**PB# 05-24**

**Sandcastle Homes  
(SP)**

SUBJECT: SANDCASTLE SITE PLAN (River Road)  
RECOMMENDATION FOR BOND REDUCTION  
Planning Board Application 05-24

SANDCASTLE HOMES SITE PLAN

DATE	SCALE	JOB NUMBER	SHEET NUMBER
12/02/05	1"=30'	05450 - A/JC	SP 6

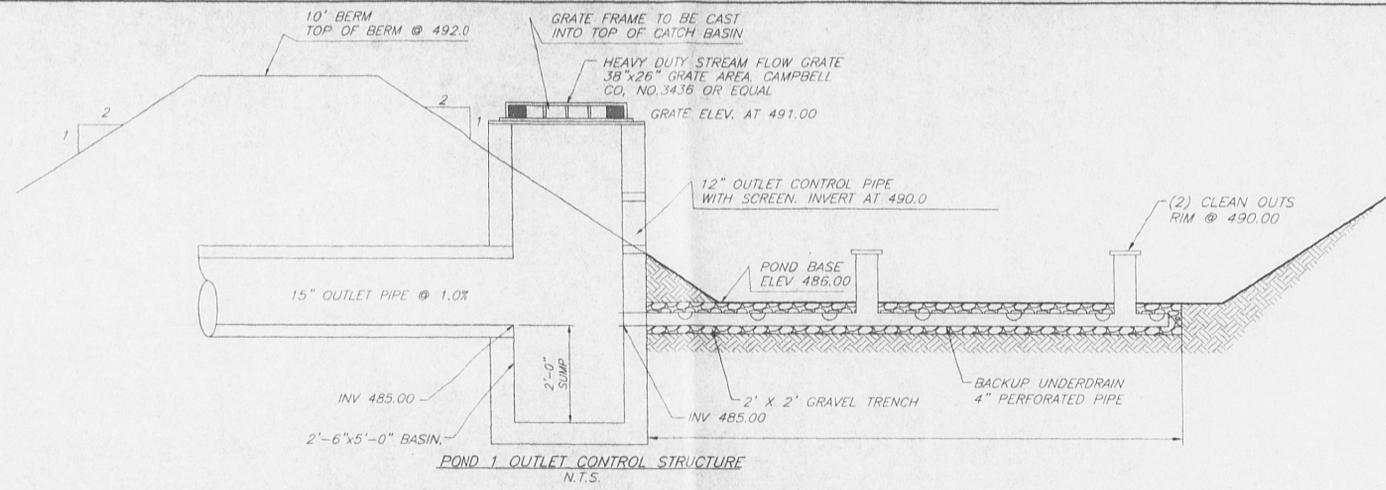
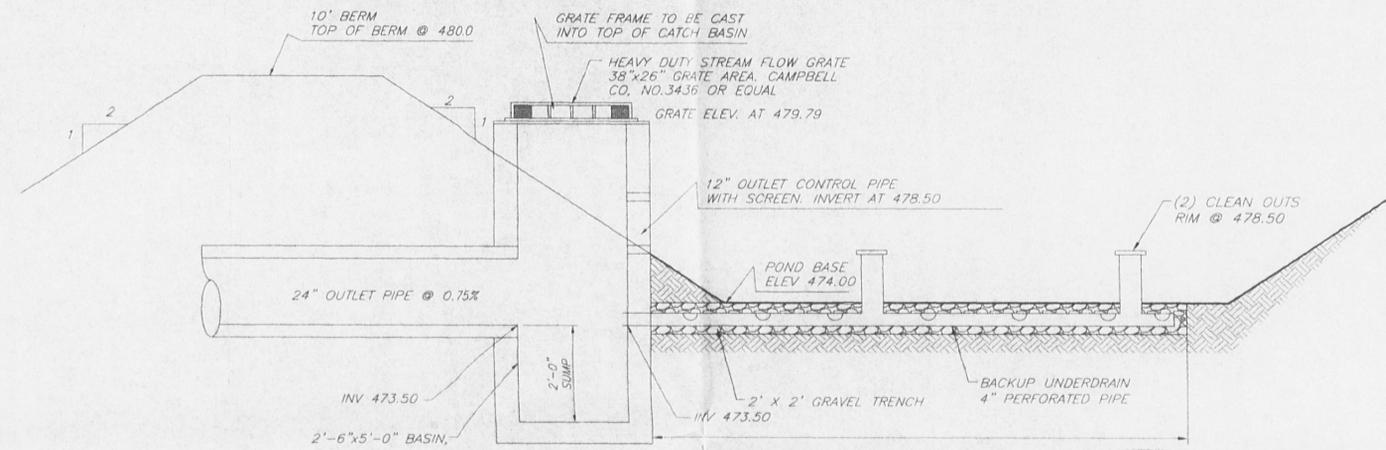
- 2) Note 7 on Sheet SP6 states that the parking lot and drainage for Lots #2 and #3 will be constructed concurrently.
- 5) Footing drains and roof leaders are shown on the Southeastern corner of the building on Lot #2.
- 7) Catch basin diversion structures are no longer required due to revised drainage.
- 8) Sheet SP-8 is the "Erosion and Sedimentation Control Plan"
- 10) The NOI will be completed upon acceptance of the proposed drainage practices.
- 11) Rolled erosion control has been specified for slopes greater than 30% in Note #2 on SP 6 and again on Sheet SP 8.

- There are several very steep areas adjoining parking lots and buildings (see grading plans, sheet SP-6). I am concerned stormwater and groundwater will surface at the bottom of these locations, and no provisions have been included to address this likelihood.

**1 Site Utility Plan**  
 SP2 1"=30'-0"

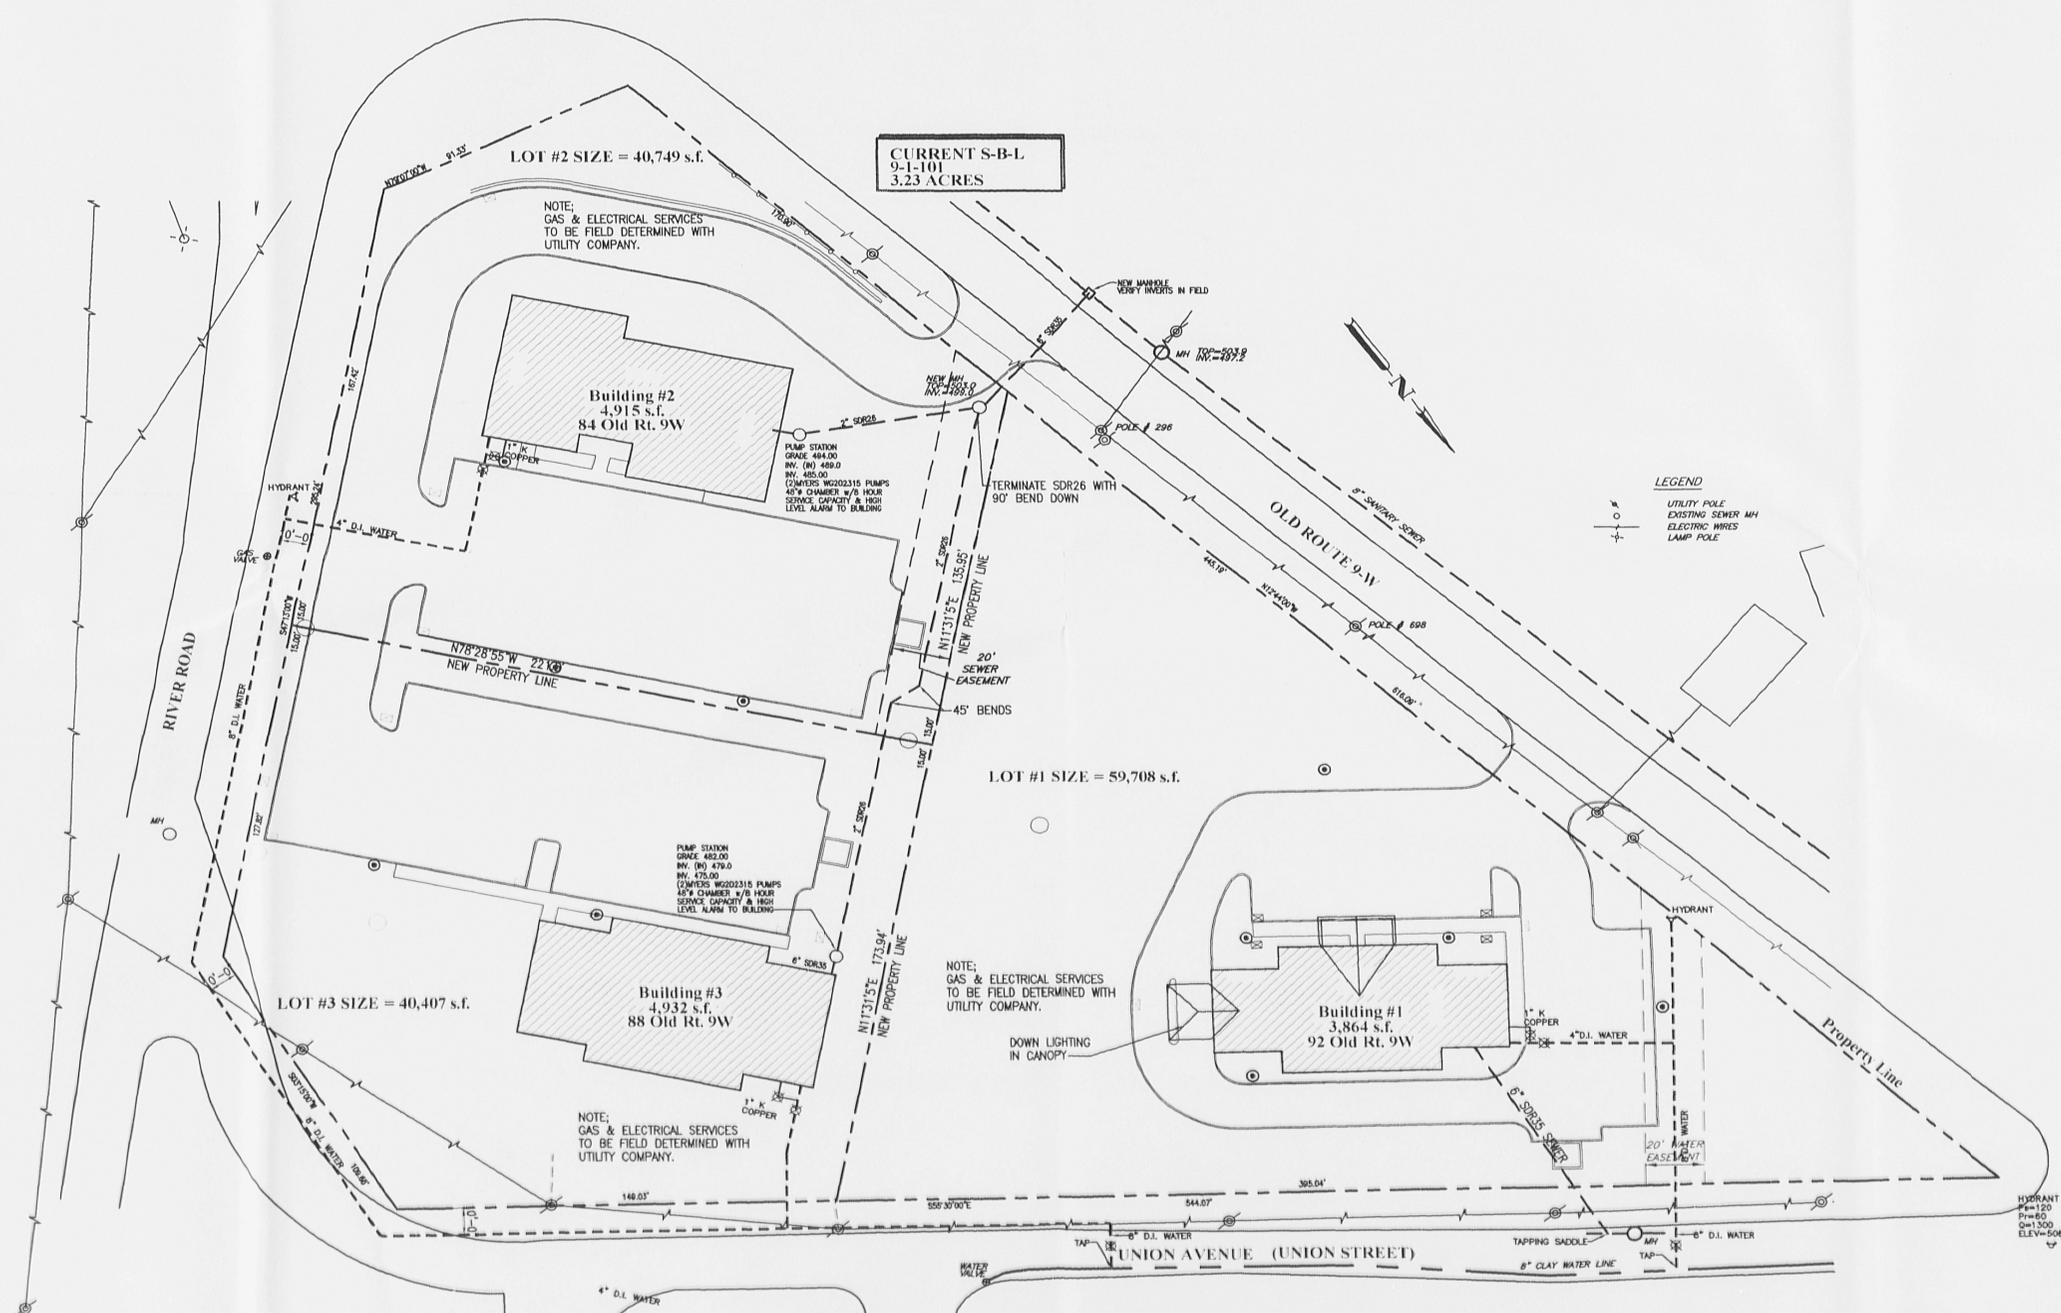
- Regarding the previous comment, the applicant should insure that all easements and references are also shown on the final subdivision plat.
- Site Plan sheet SP1 should call out the location of the handicapped drops/ramps to the sidewalks.
- For site #1, I suggest a “Do Not Enter” sign be added on the “outlet” side of the drive thru lane. Also, as previously suggested, a directory sign (directing drive thru traffic) should be added.
- The plan should provide a reference to the source of the boundary survey data shown on this plan, and a copy of the survey should be provided to the Planning Board for file.
- No waste enclosure is provided for Site #1. It is assumed that there will be some type of waste generated.
